## **NOTICE OF MEETING**

**Monday July 9, 2018**

1. Pledge of Allegiance
2. Approve Agenda
3. Approve Minutes
  - a. May 30, 2018
  - b. June 4, 2018
  - c. June 18, 2018
4. Public Hearings
  - a. **CONDITIONAL USE PERMIT AND VARIANCE REQUESTS.** A request by Verizon Wireless, 10801 Bush Lake Road, Bloomington, MN 55438, for a conditional use permit for a proposed 125-foot monopole telecommunications tower and nine foot lightning rod for a total 134-foot above ground level tower and variances from the required maximum height standards; setback; and expiration dates of permit, variances, and conditional use permit. 11351 Upper 33<sup>rd</sup> Street North PID #13.029.21.31.0018.

**FIGURE 5 - EXISTING TOWER SEARCH**

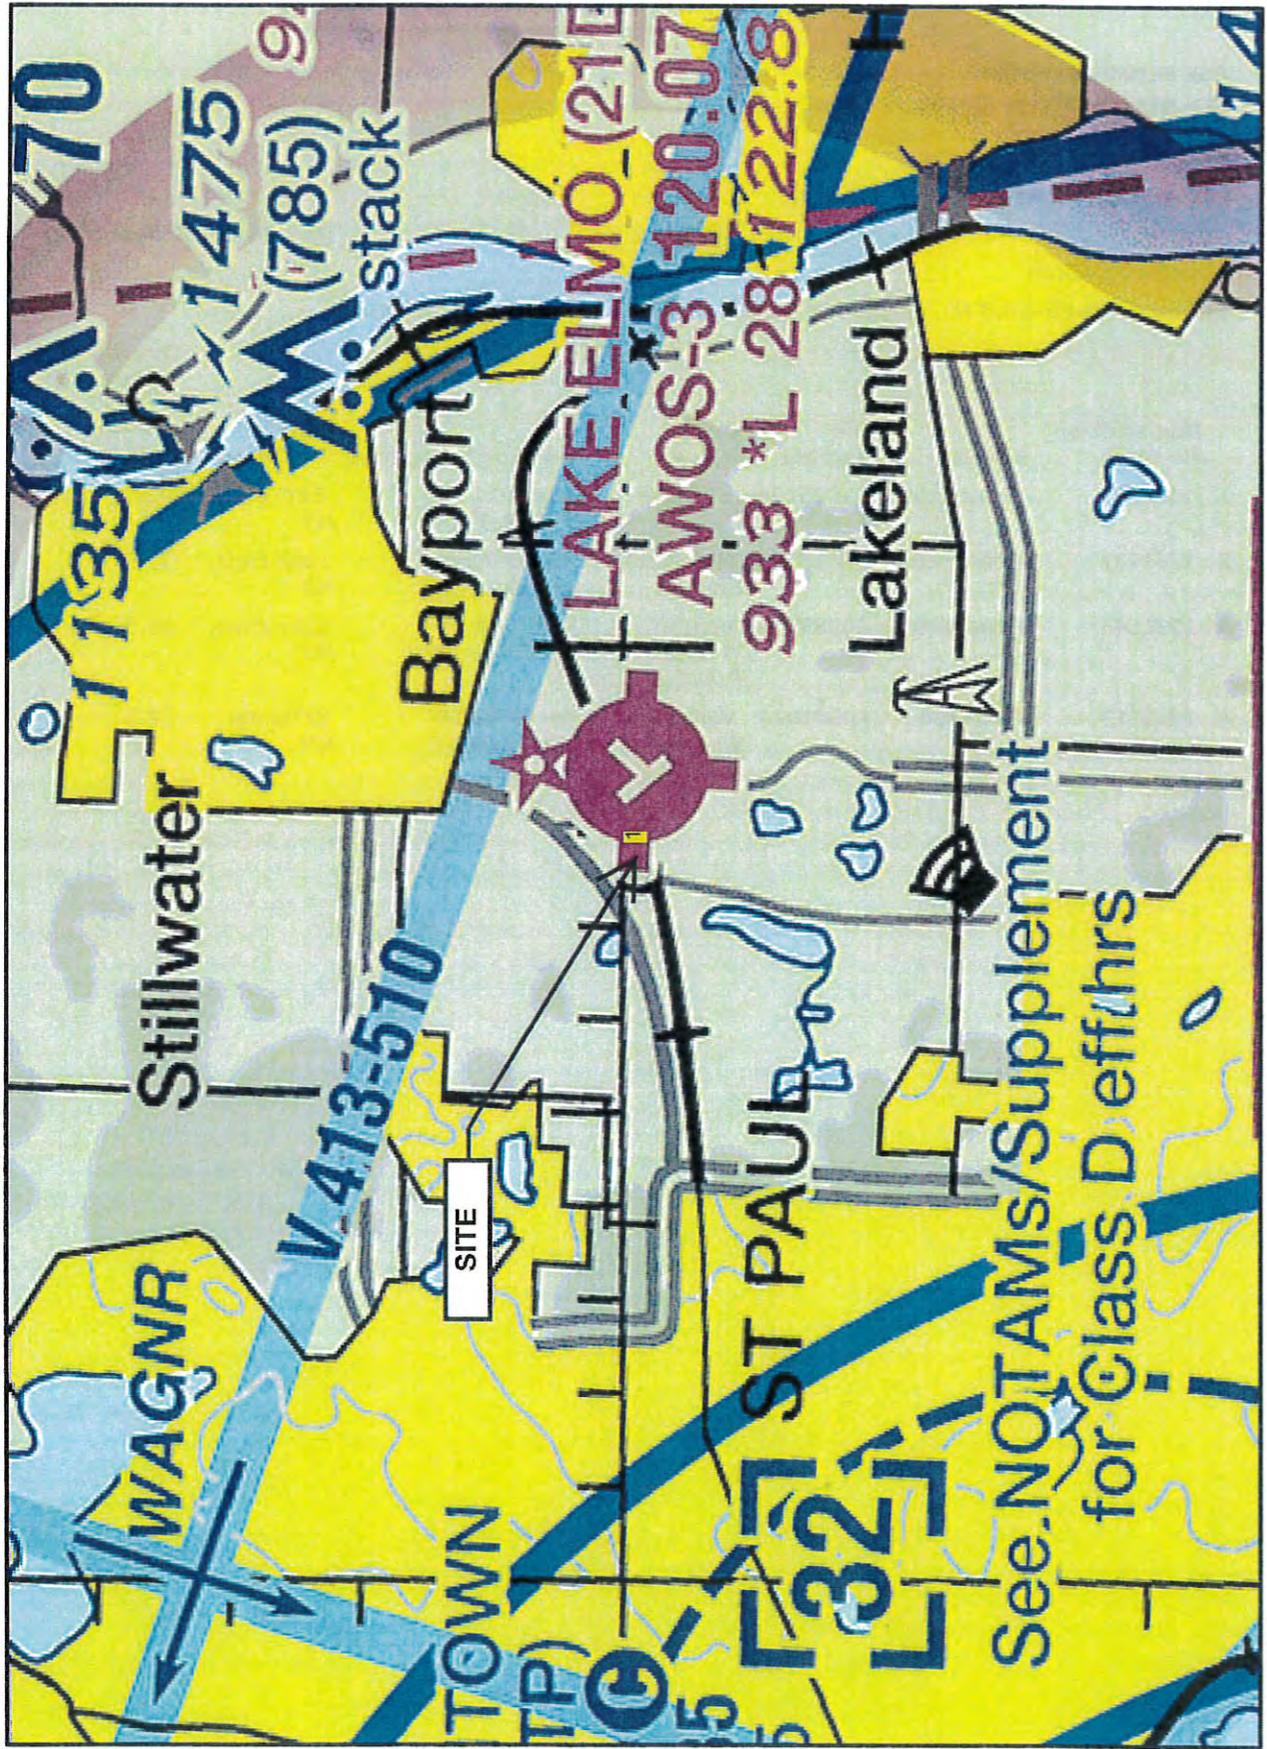
A search of both FCC and FAA databases was performed to determine the location of any potential alternate locations for the proposed monopole. Figure 5 shows the results of this search. The four nearest towers were reviewed as possible substitutes for the proposed tower. They are:

FIGURE 8A - PROPOSED COVERAGE

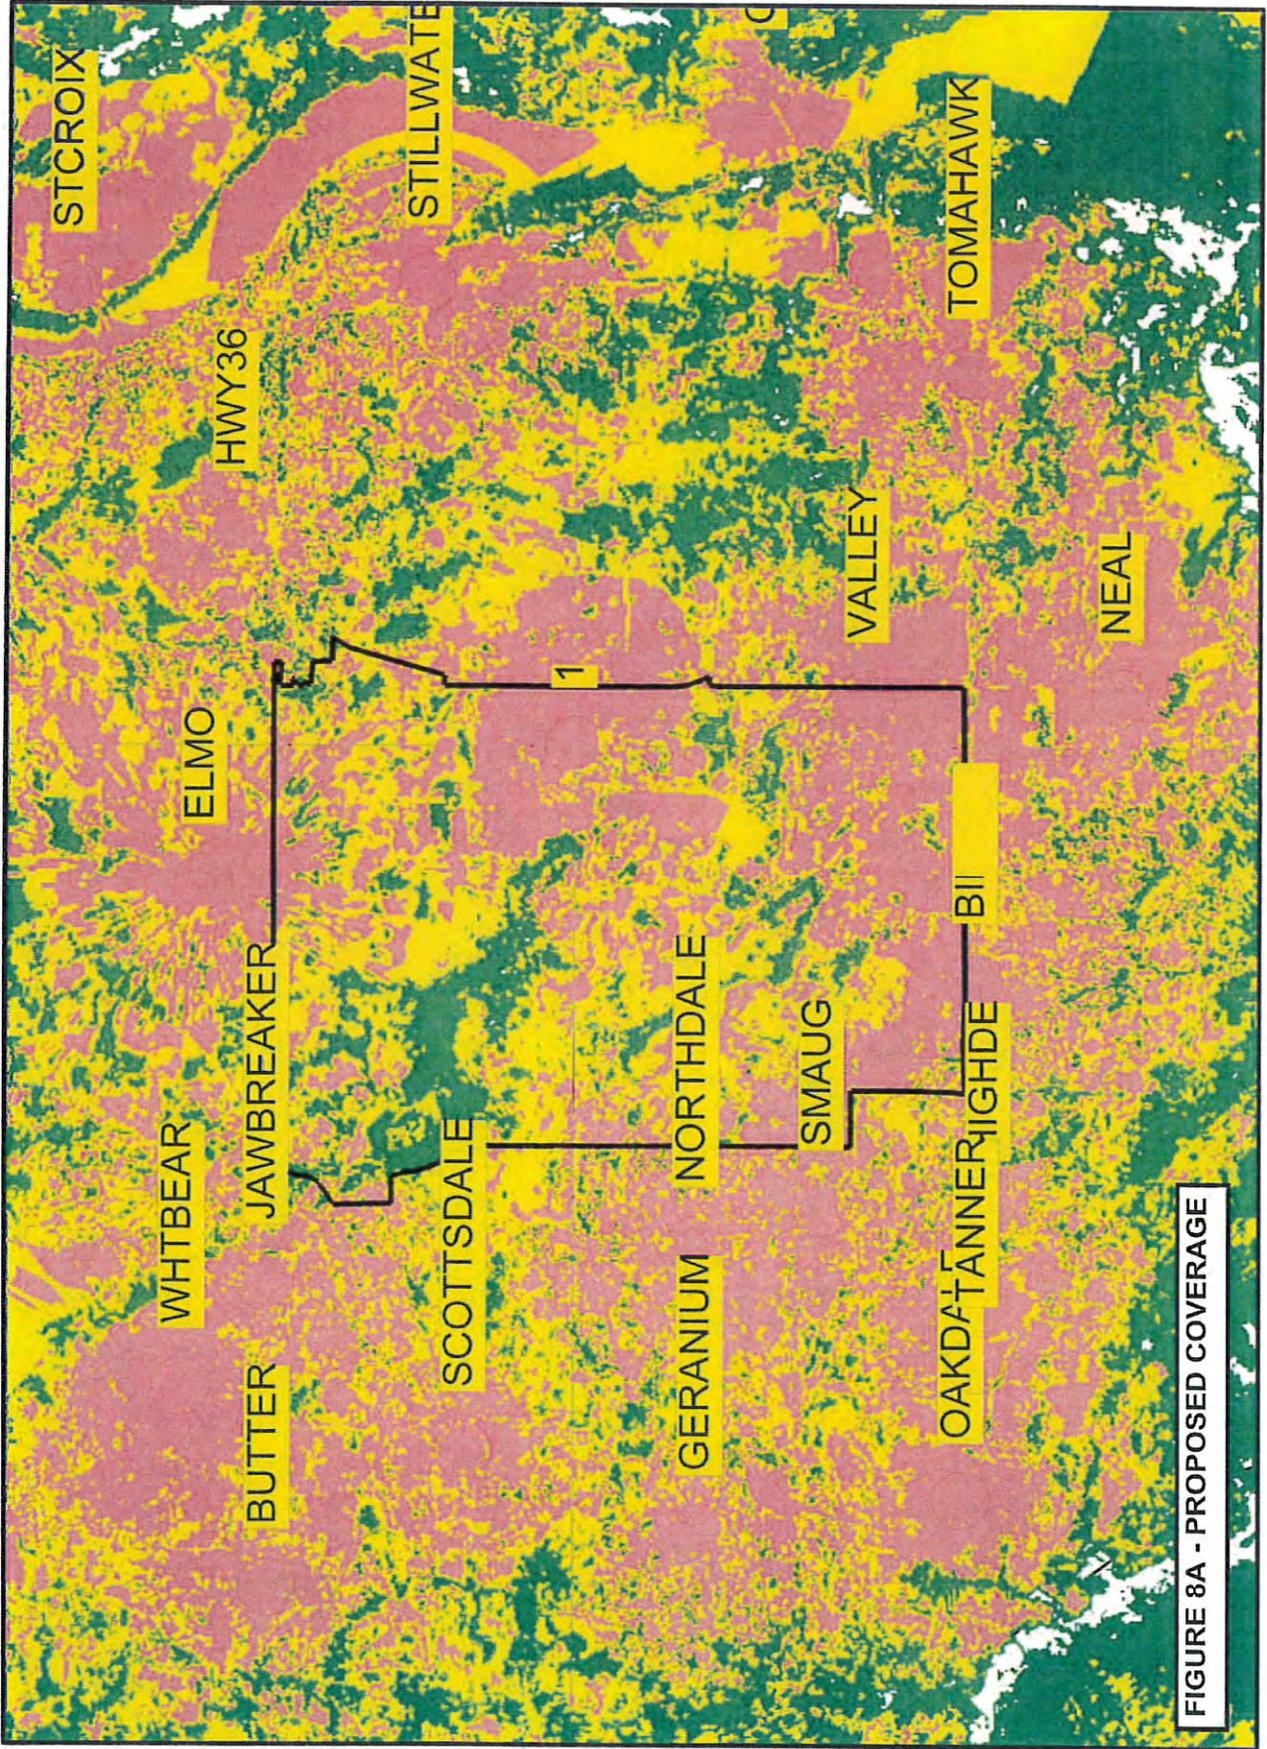
I was able to complete my analysis of the application. Figure 8a shows the predicted coverage area with the new monopole. Figure 8b shows the area with the proposed monopole removed from the analysis and the predicted coverage gap is identified. Figure 8c shows the coverage with the tower height reduced to 80-feet and will not eliminate the predicted coverage gap.
